Re: Proposed construction of 39 residential units, widening of Pausdeen Bridge and all associated site works.  
Newtown/Ardclough Road, Newtown, Celbridge, Co. Kildare.

## Planning Observation Submissions to An Bord Pleanála

## Areas of Concern for the Residents of Chelmsford

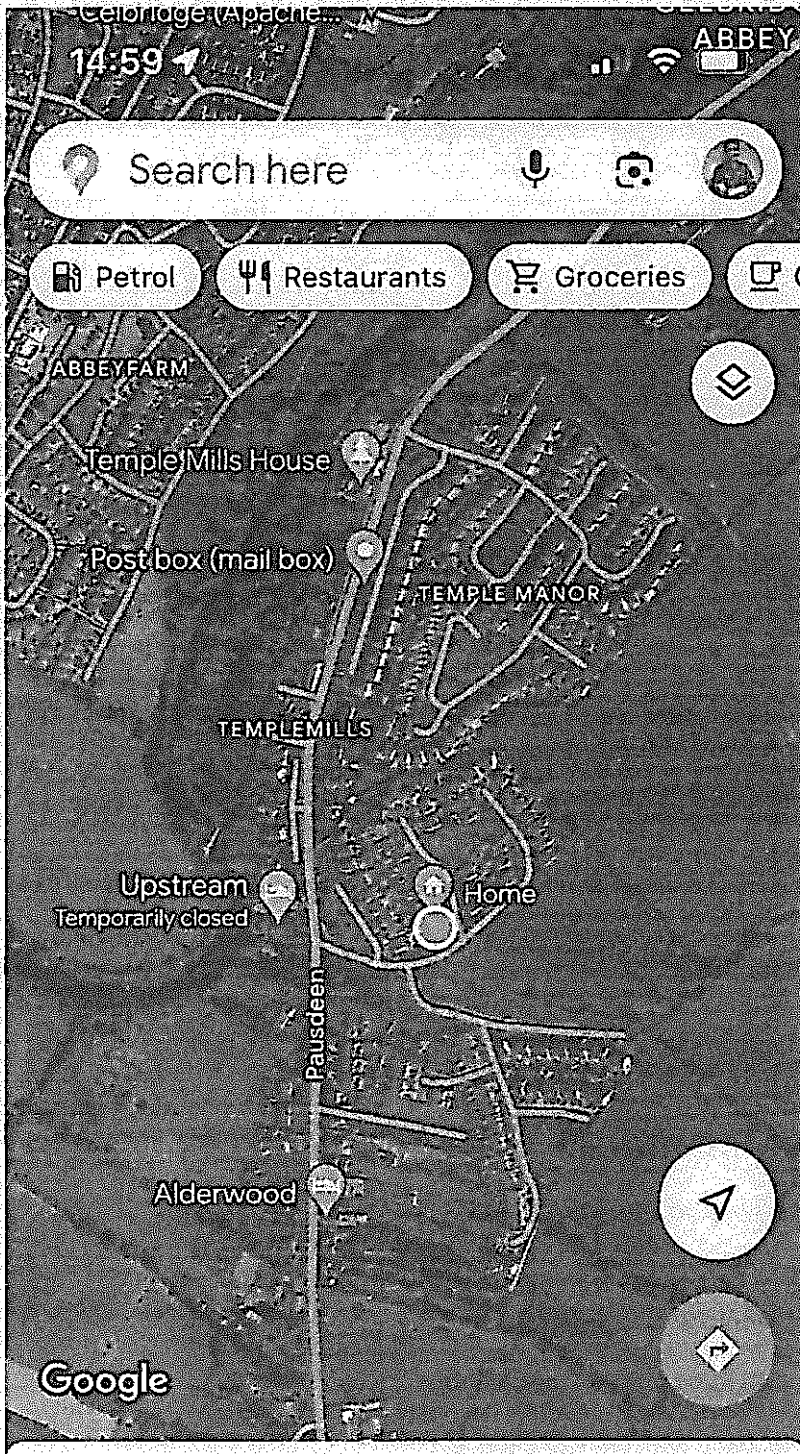
The diagram below shows that the site boundary (40m from river) would be the closest development to the flood plain on the west side of the Ardclough Road. No other development is as close to the Liffey flood zone on the southern side of the river.

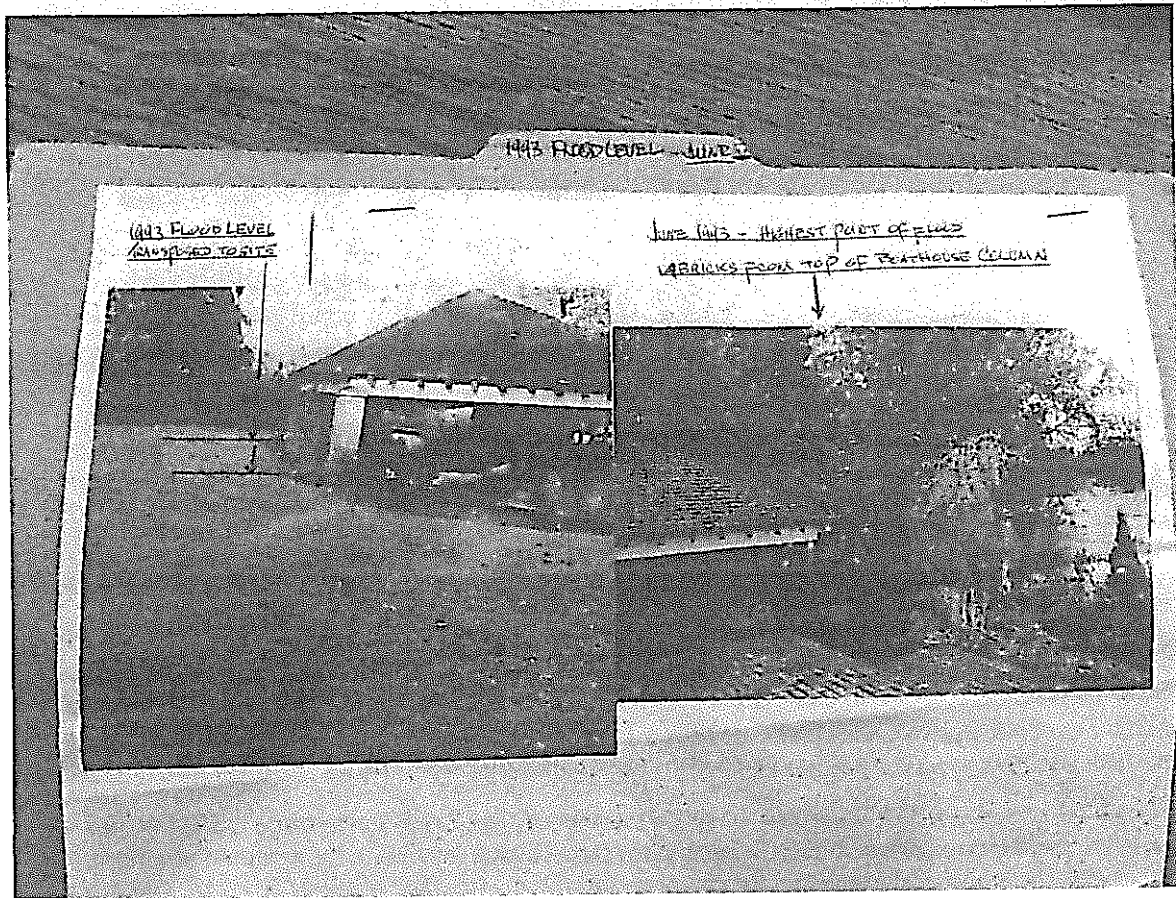
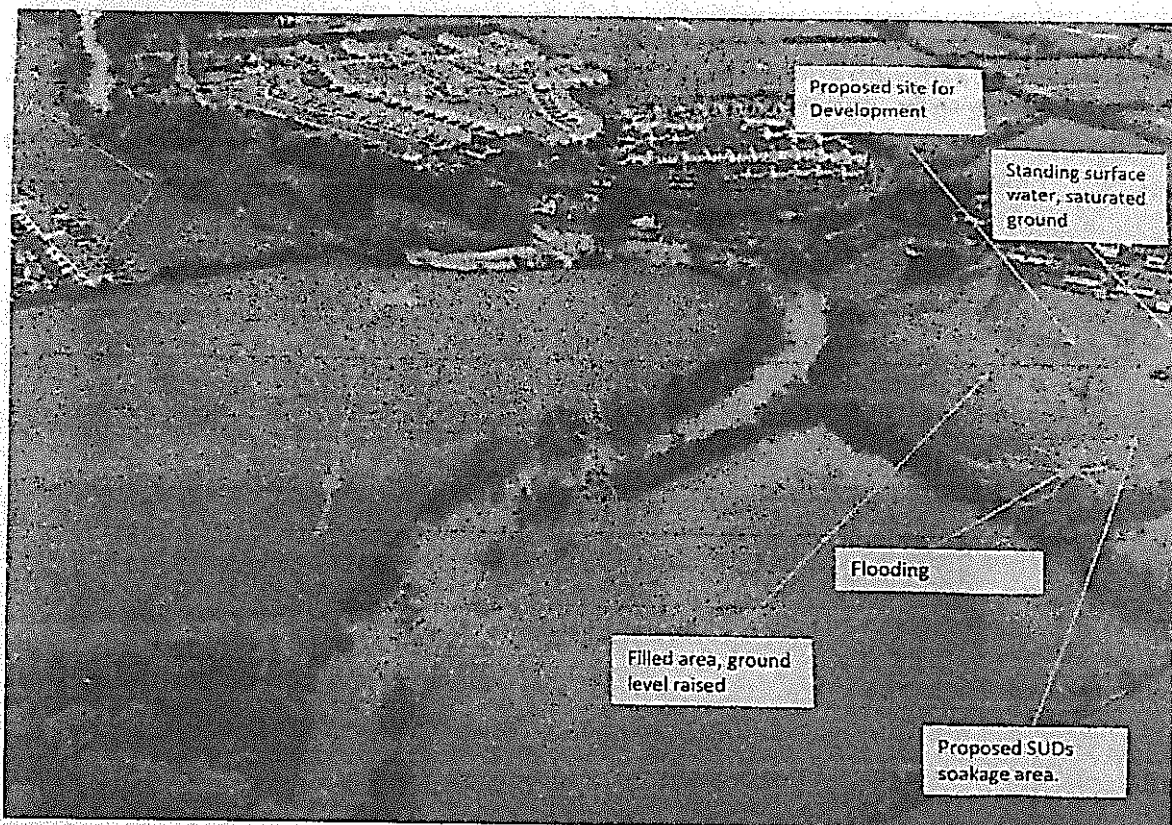
Section 2.2 of the report states that there was flooding in 1954 which affected the area with no major flooding events since. Event 2176 as per figure 2-1 of Tobins report. The residents of Newtown believe that flooding has occurred previously on the site in the last 30 years. Photos are included from residents.

Location: Drawing 210303-2-007 – Rev – VHA, Pedestrian Bridge

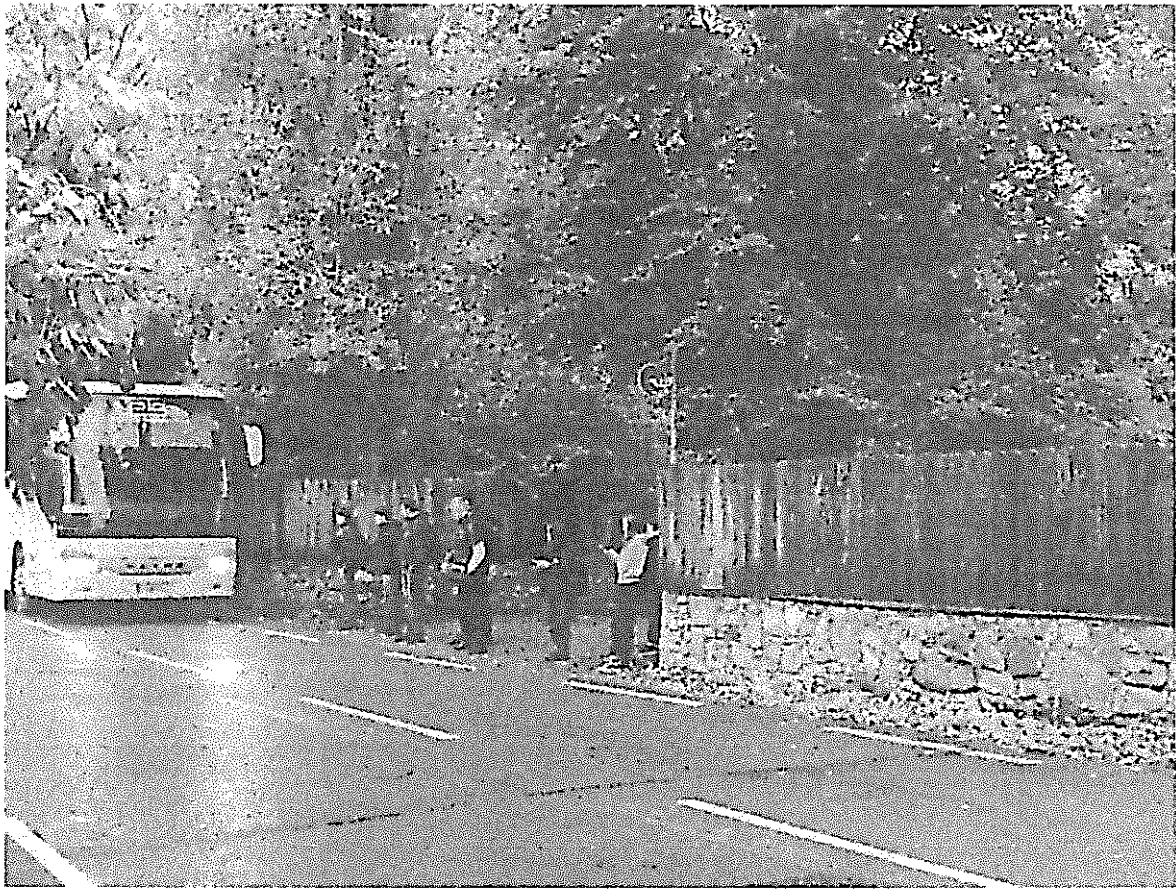
Section: 3.8 problem

Information in the Bruton Consulting Engineers Road Safety report is not true or correct. The entrance at Chelmsford is an extremely busy junction during peak times (Work / School Times etc.). The entrance is the only access to Chelmsford and Chelmsford Manor Housing Estates which has a total of 95 Residential houses. Each house has an average of two motor vehicles which in turn means 190 motor vehicles can pass through the entrance at any one time. There is no dedicated bus stop for the children of Chelmsford going to school. This applies to the new Council Estate in Newtown recently acquired and the proposed site. There are no bus stop facilities at Simmonstown and Templemanor for children going to school on the bus. Note that cycling is not an option as there are no cycling routes.

It is recommended that an uncontrolled crossing be provided. As it is a very lightly used entrance the footpath could be made continuous to give better priority to pedestrians.

**Location: Drawing 210303-2-007 – Rev – VHA, Pedestrian Bridge**

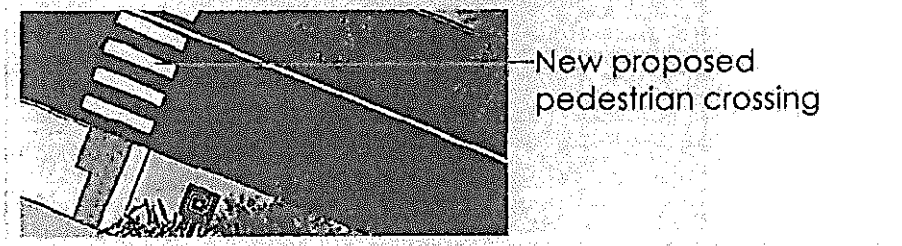
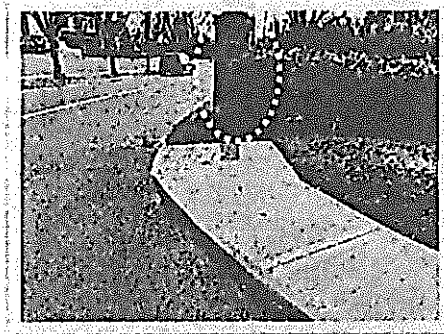
**Section: 3.9 problem**

The information in the Bruton Consulting Engineering Report or KCC Planning Application Report does not consider the ownership of the Common Green Areas at Entrance along with the two Pillars at the entrance to Chelmsford. The lands are not owned by the County Council, and they will need permission from the owner to carry out any works on this proposed site.

Resolution: The Chelmsford Residents Association should be given documented evidence that permission from the owner that any works on the planning application for bridge widening and new proposed zebra crossing has been given.
